Wisconsin Department of Transportation

Proposal #43: 1228-22-74, WISC 2023175
IH43 North-South Freeway
Hampton Ave.-SB Ramp over Milw Rvr
IH-43
Milwaukee County

This is Addendum No. 1, which provides for the following:

ADDENDUM NO. 01

Addendum No. 01
ID 228-22-74
Revised Sheet 9
December 20, 2023

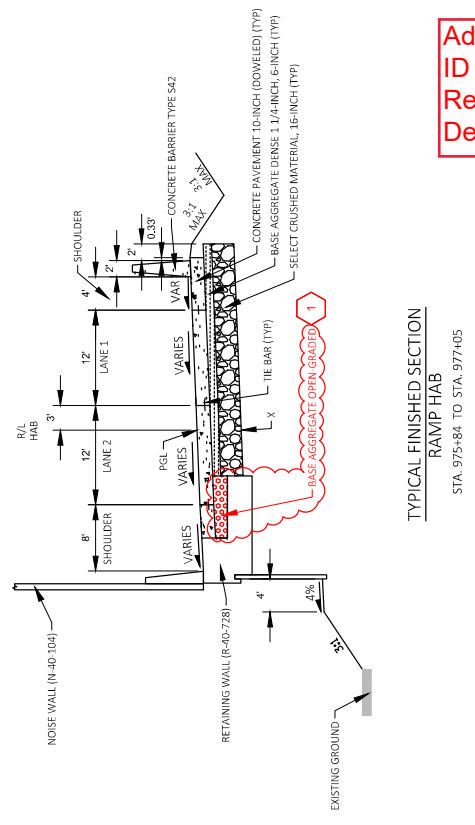
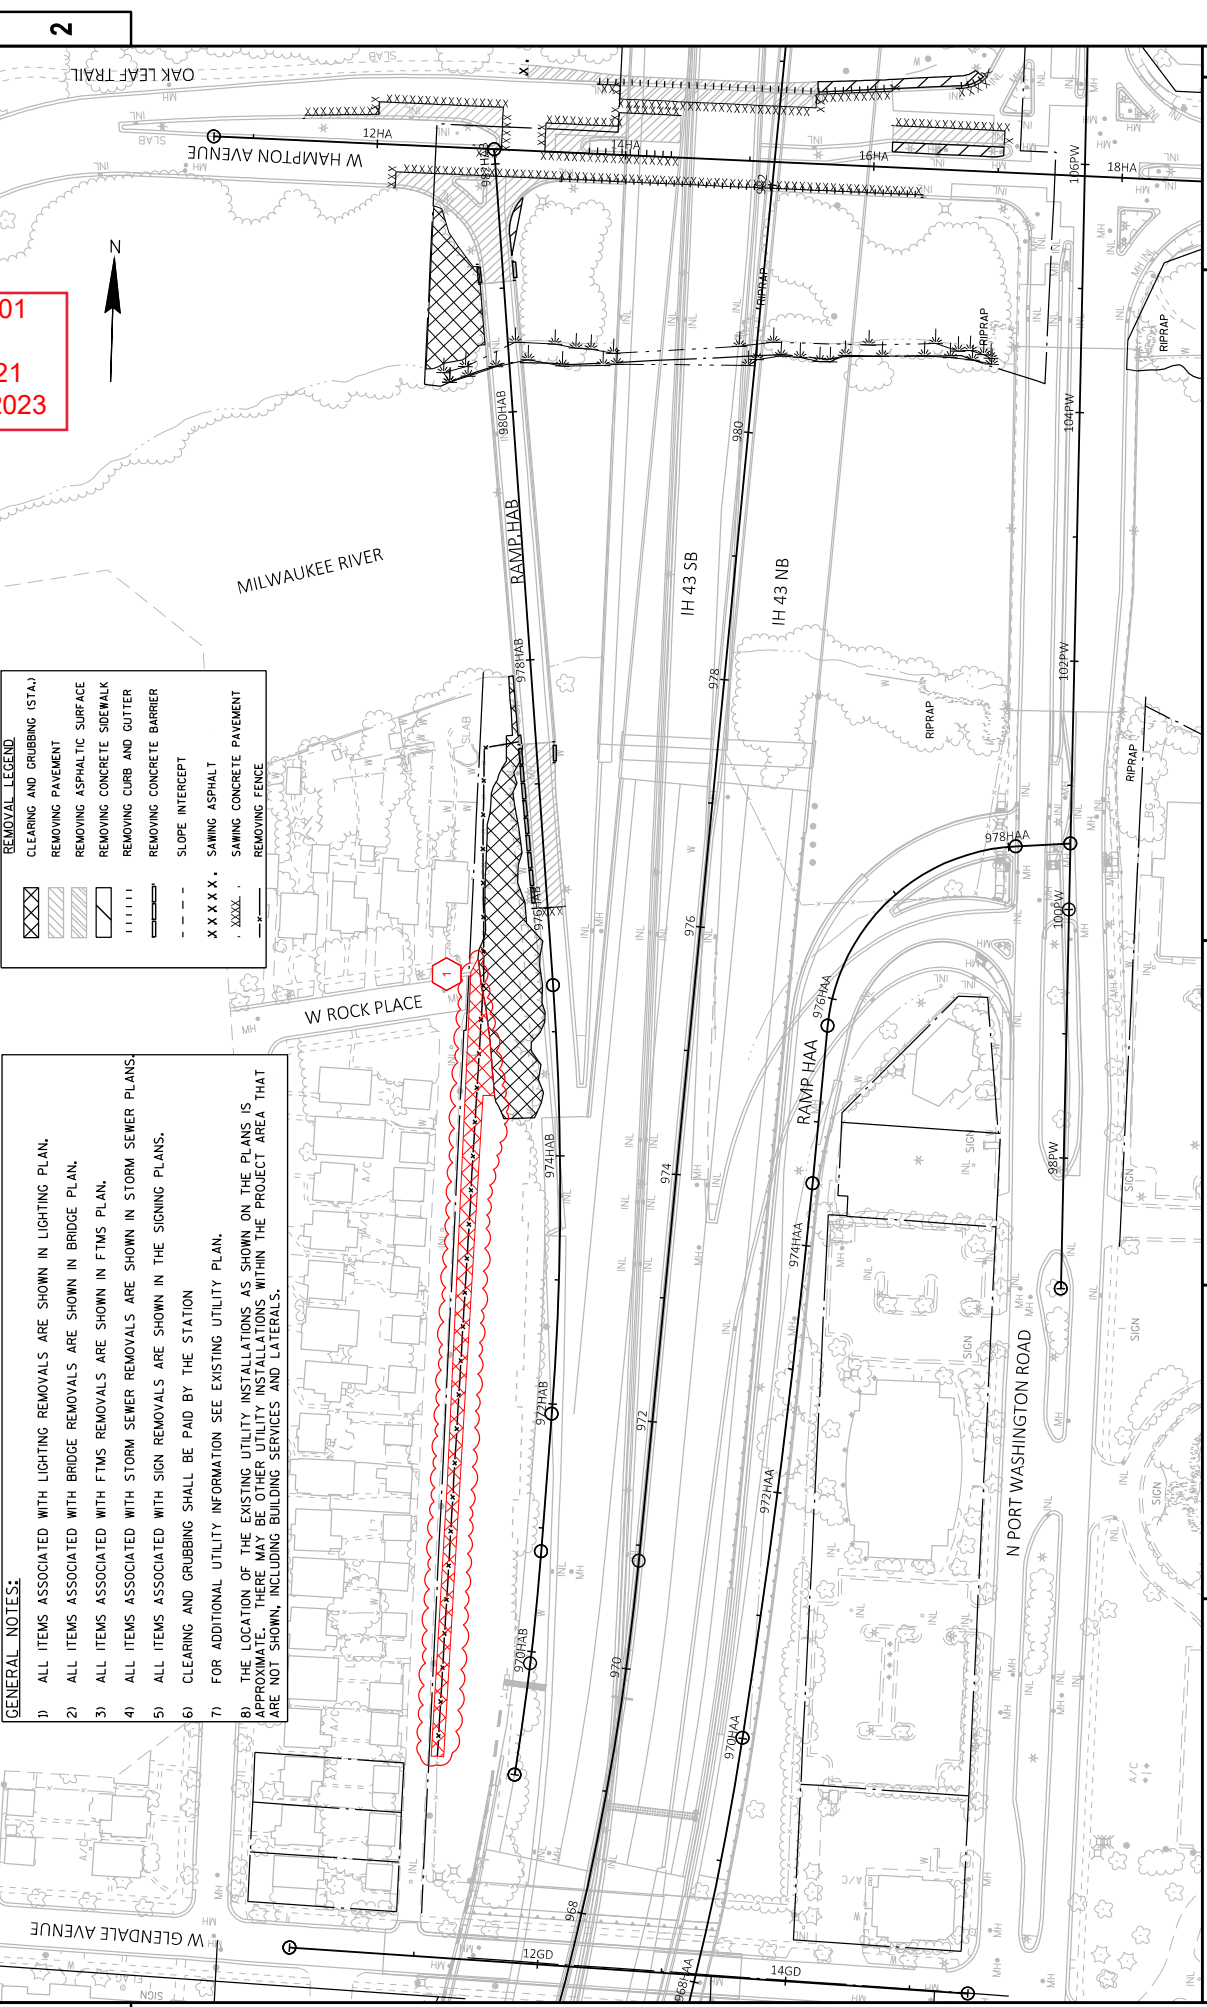
Revised Plan Sheets	
Plan Sheet	Plan Sheet Title (brief description of changes to sheet)
9	Typical Sections; Changed base material above moment slab from Base Aggregate Dense 1 1/4-Inch to Base Aggregate Open-Graded.
21	Removals; Additional clearing & grubbing for existing fence removal.
24	Plan Details; STA/OFF callouts added to MGS and EAT.
47	Storm Sewer Details; Modified notes referring to standard spec book.
48-49	Storm Sewer Plan & Profile; Added an inlet and pipe, and changed an inlet replacement to a reconstruct.
52	Permanent Signing; Additional existing sign removal and replacement.
55	Lighting Plans; Additional pullbox removal.
93	Miscellaneous Quantities - Roadway; Additional clearing & grubbing for existing fence removal.
95	Miscellaneous Quantities - Roadway; Changed base material above moment slab from Base Aggregate Dense 1 1/4-Inch to Base Aggregate Open-Graded.
103-104	Miscellaneous Quantities - Drainage; Updated drainage quantities.
